MIDLAND PROJECT -
DOCKET NOS 50-329 and 50-330
BORATED WATER STORAGE TANK FOUNDATION OL DESIGN CALCULATIONS
FILE 0485.16, 0.4.9.49 SERIAL 17159

MIDLAND PLANT UNITS 1 AND 2
RESPONSE TO THE NRC STAFF REQUEST FOR ADDITIONAL INFORMATION
REQUIRED FOR COMPLETION OF STAFF REVIEW OF THE BORATED WATER
STORAGE TANK AND THE UNDERPINNING OF THE
SERVICE WATER PUMP STRUCTURE

BORATED WATER STORAGE TANK(S) FOUNDATION REPAIR

FIGURE BWST-1

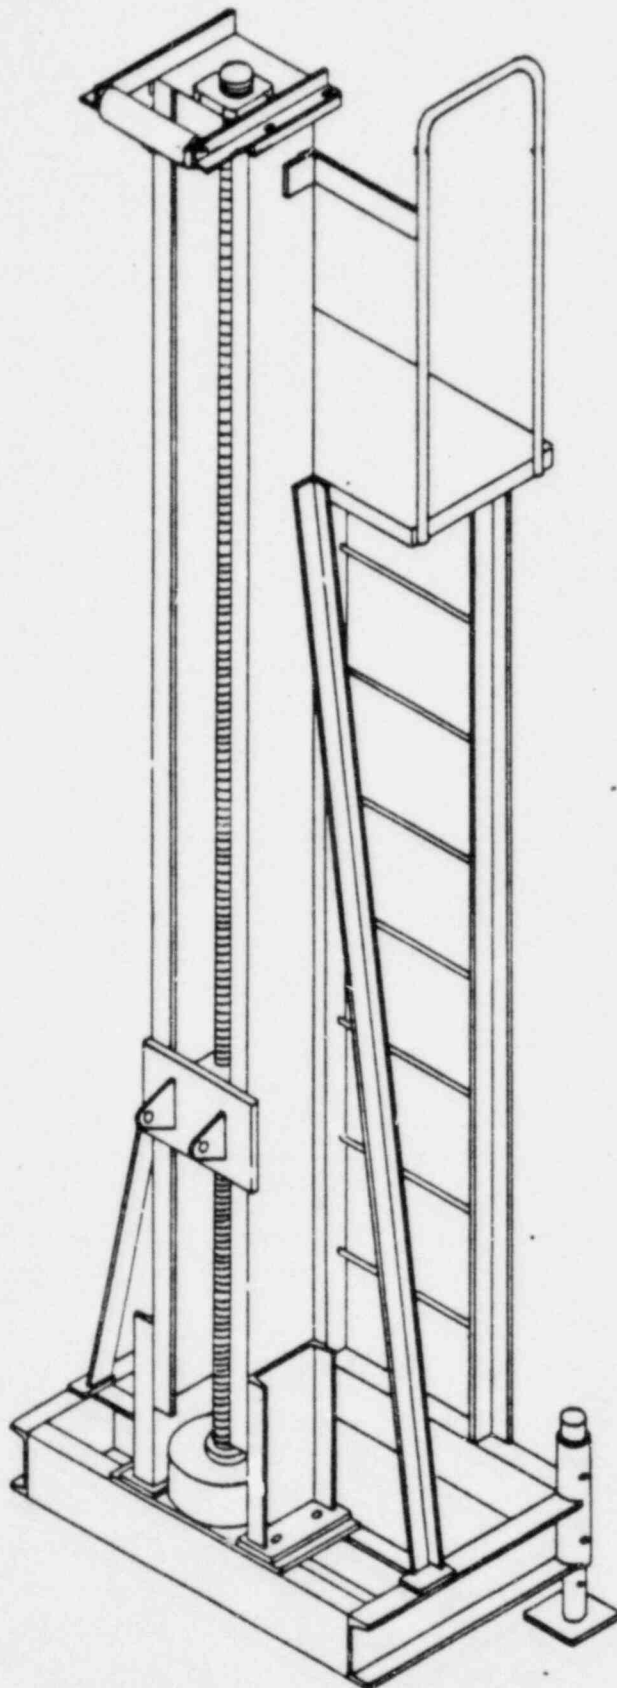
Provide a detailed releveled procedure for the Unit 1 tank.

Fourteen hydraulic jacks (see Figure BWST-1) will be located beneath the anchor bolt chairs and sequentially raised to lift the bolt chairs beyond the top of the bolts. The tank will be supported by wooden dunnage. At this point, 14 electromechanical jacks placed between the hydraulic jacks will be connected to complete the lift (see Figure BWST-2). The electromechanical jacks will be controlled from a central panel allowing the jacks to operate in unison to raise and lower the tank. The total tank lift will be at least 3 feet. Wooden dunnage will be placed between the tank bottom and ring wall for stable support during subsequent work. Strain gages will be monitored to confirm that the tank stresses remain within allowable limits.

FIGURE BWST-7

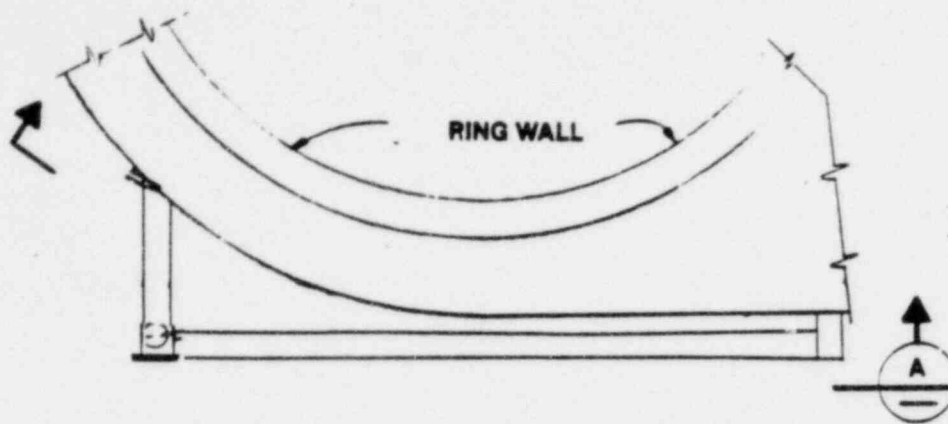
Provide strain monitoring details, procedures, and acceptance criteria for new ring beam.

During the plant construction and operation periods, the strain measurements will be taken at the locations on the ring beam of both tanks as shown in Figure BWST-7.
